Access Compliance Report

Public Rights-of-Way

Intersection ID: 45502	Main Street: CAPTAIN_ARDREY_RD	Cross Street: TRIPLE_OAK_RD	Location: E
ADA ID: 42D5A064A5DD	Ramp Type: PerpDiag	Initial Pass/Fail: Fail	Overall Compliance: No
		Severity Score: 35

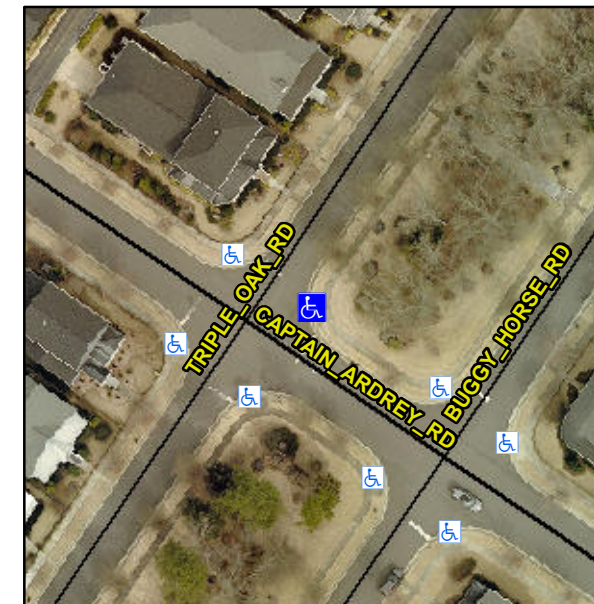
Not Found, R304.5.1, R304.2.2, R304.5.3

Compliance	Description	Data	Compliance	Description	Data
N/A	Ramp Length (in)	72.0	No	Ramp Slope (%)	12.8
No	Ramp Width (in)	36.0	No	Ramp XSlope (%)	2.4
N/A	Flare Type LT	N/A	N/A	Flare Type RT	N/A
N/A	Flare Slope LT (%)	N/A	N/A	Flare Slope RT (%)	N/A
N/A	Flare Traversable LT?	N/A	N/A	Flare Traversable RT?	N/A
N/A	Landing Length (in)	N/A	N/A	DWS Provided?	N/A
N/A	Landing Width (in)	N/A	N/A	DWS Contrast?	N/A
N/A	Landing Slope (%)	N/A	N/A	DWS Length (in)	N/A
N/A	Landing X Slope (%)	N/A	N/A	DWS Full Width?	N/A
N/A	Landing Curb? (Y/N)	N/A	N/A	DWS Offset (in)	N/A
N/A	Shared Landing?	N/A			
N/A	Gutter Ponding?	N/A	N/A	Gutter Slope (%)	N/A
N/A	Gutter Lip Ht (in)	N/A	N/A	Gutter X Slope (%)	N/A
N/A	Painted X Walk1?	No	N/A	Painted X Walk2?	No
	X Walk 1 Direction	To NW		X Walk 2 Direction	To SW
N/A	X Walk 1 Width (in)	N/A	N/A	X Walk 2 Width (in)	N/A
	X Walk 1 Slope (%)	3.8		X Walk 2 Slope (%)	1.8
	X Walk 1 X Slope (%)	0.5		X Walk 2 X Slope (%)	2.5

Remove & Replace Curb Ramp With Two New Directional Ramps or Equivalent.
